RESPONSE TO REQUEST FOR ADDITIONAL INFORMATION

APR1400 Design Certification

RAI No.: 479-8605
SRP Section: 09.02.01 - Station Service Water System
Application Section: 9.2.1
Date of RAI Issue: 05/10/2016

Question No. 09.02.01-8

Figure 9.2.1-1 Essential Service Water System Flow Diagram

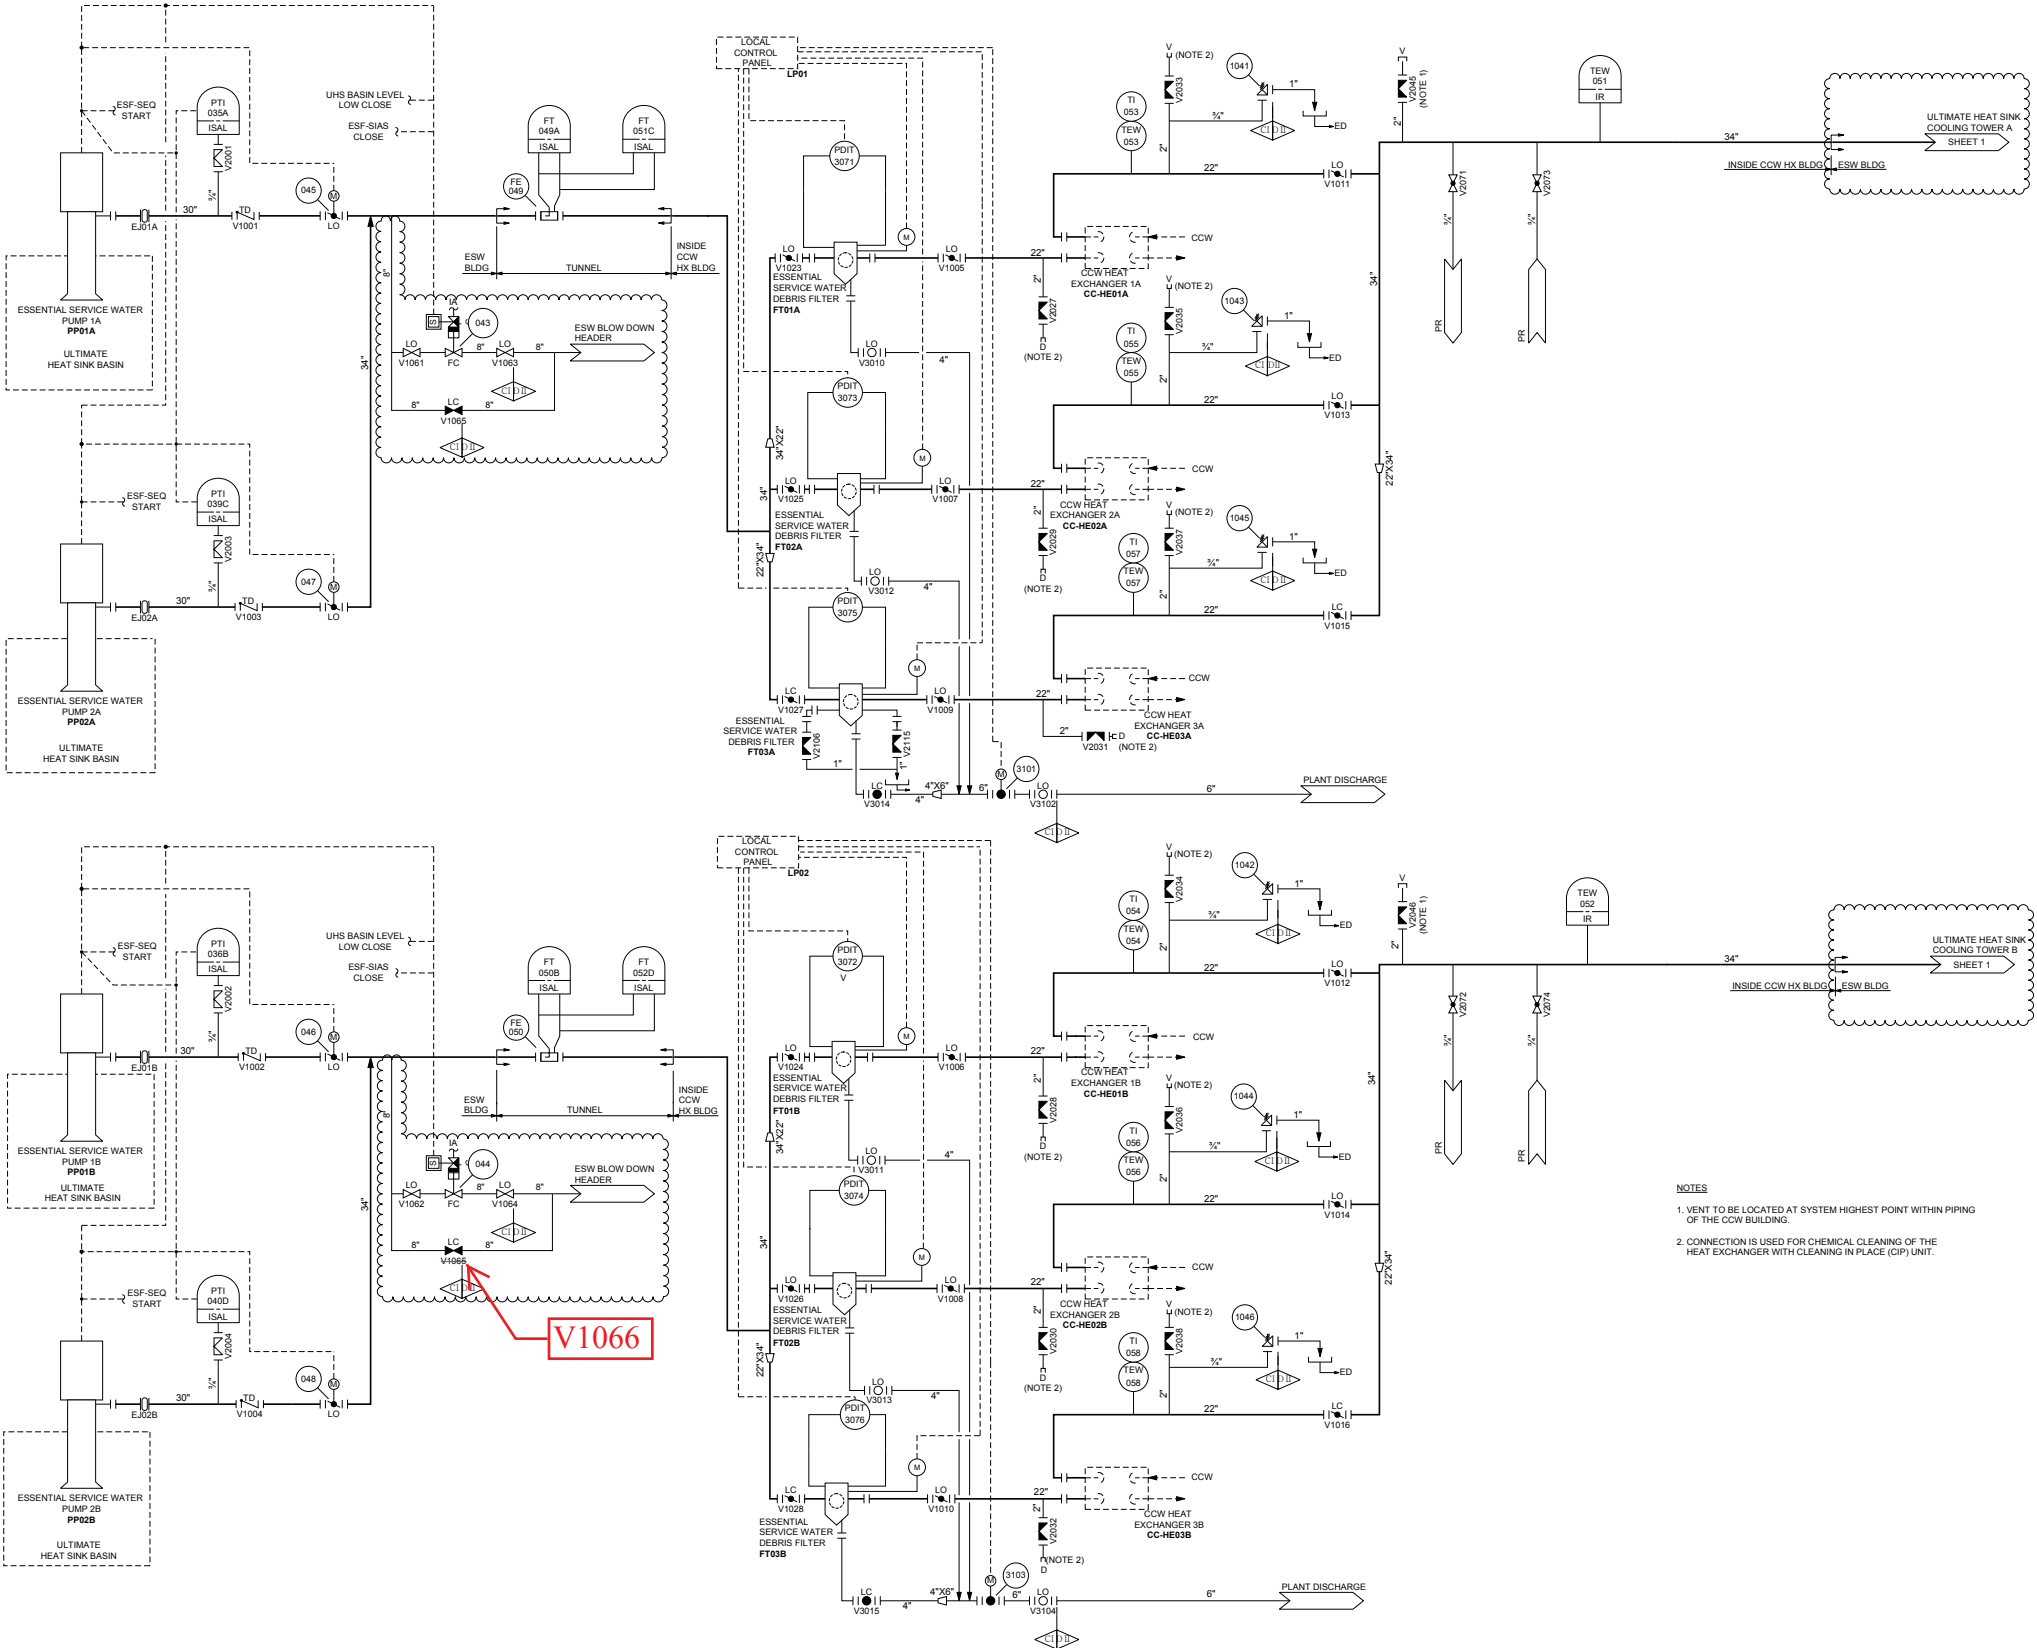
In RAI 211-8236, Question 09.02.01-4, the staff requested the applicant to clarify whether the boundary isolation valves separating the nonsafety- from the safety-related portions of the ESWS are included for inservice testing and inspection.

The first part of the response that “the boundary isolation valves are not included for in-service testing and inspection” is inconsistent with the second part of the response that “they are used only for system or component maintenance, in accordance with ASME ISTC code requirements.”

The staff’s understanding from the response and other design certification applications is that the boundary isolation valves are tested in accordance with ASME OM Code Subsection ISTC, “Inservice Testing of Valves in Light-Water Reactor Nuclear Power Plant.” The applicant is requested to confirm and revise the response, and incorporate it into the DCD.

V1065 of Figure 9.2.1-1 in DCD Tier 2 will be corrected to V1066 as indicated in the attachment.

In DCD Tier 2, Figure 9.2.1-1 will be corrected as indicated in the attachment.
